UNITED STATES PATENT AND TRADEMARK OFFICE

Office Action Summary	Application No. 10/573,696	Applicant(s) LEIMBACH ET AL.	
	Examiner JONATHAN M. HANSEN	Art Unit 2886

DETAILED ACTION

Fig. 1

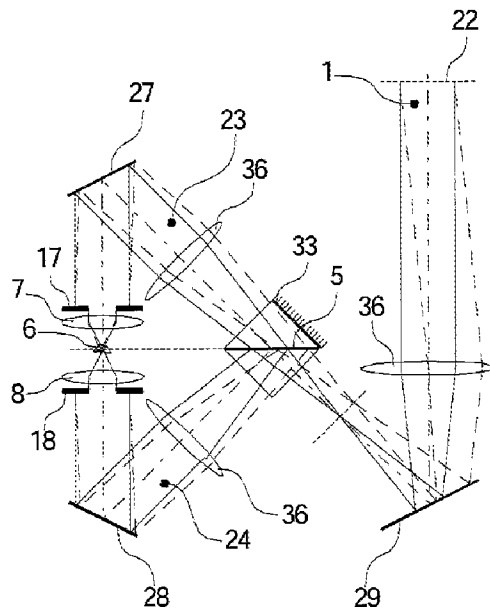
In regards to claim **1**, Bewersdorf discloses and shows in Figures 1 and 3 below, a 4Pi microscope comprising:

an interferometer in which two objectives (7 and 8) are positioned to oppose one another on different sides of an object plane (6), and having an optical element (5) for coupling illuminating light (1) into the interferometer and for coupling detected light (23 and 24) out of the interferometer and for directing it into a detection beam path (22), a detected light portion

being coupled out by the optical element and not directed into the detection beam path (par. 76 and 77); and

a reflecting device (33) configured to reflect illuminating light coupled out by the optical element back into the interferometer and to reflect the detected light portion coupled out by the optical element that is not directed into the detection beam path back into the interferometer (par. 76 and 77).

In regards to claim **15**, Bewersdorf discloses the 4Pi microscope, wherein the beam splitter is a beam splitter cube (Figure 1).

In regards to claim **16**, Bewersdorf discloses the 4Pi microscope, wherein the reflecting device (33) is positioned directly at the beam splitter (5) (Figure 1).

FIG. 4B

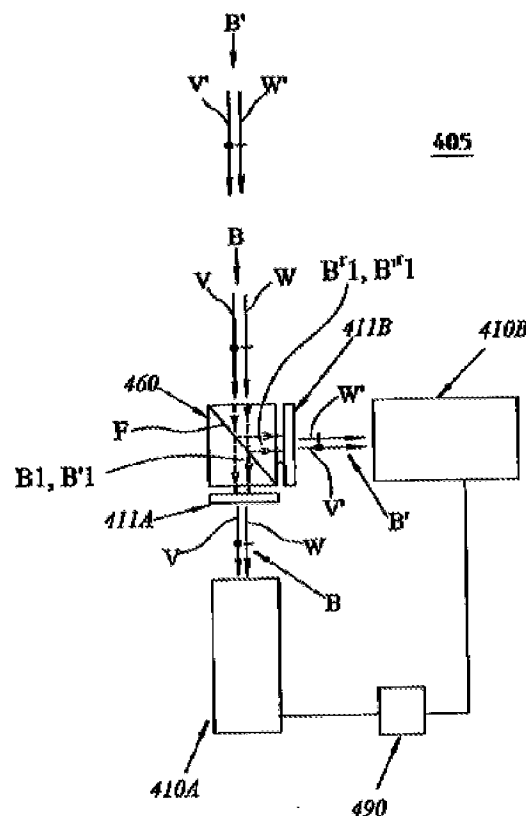
In regards to claim **19**, Bewersdorf differs from the limitations in that he is silent to wherein the reflecting device has color-selective reflecting properties

However, Szwaykowski teaches a beam splitter that uses wavelength selective surfaces in lieu of optical filters to limit the wavelengths that are transmitted and reflected (par. 52).

Therefore, it would have been obvious to one of ordinary skill in the art at the time the invention was made to modify Bewersdorf to wherein the reflecting device has color-selective reflecting properties for the advantage of substituting optical filters for wavelength selective surfaces to yield predictable results.
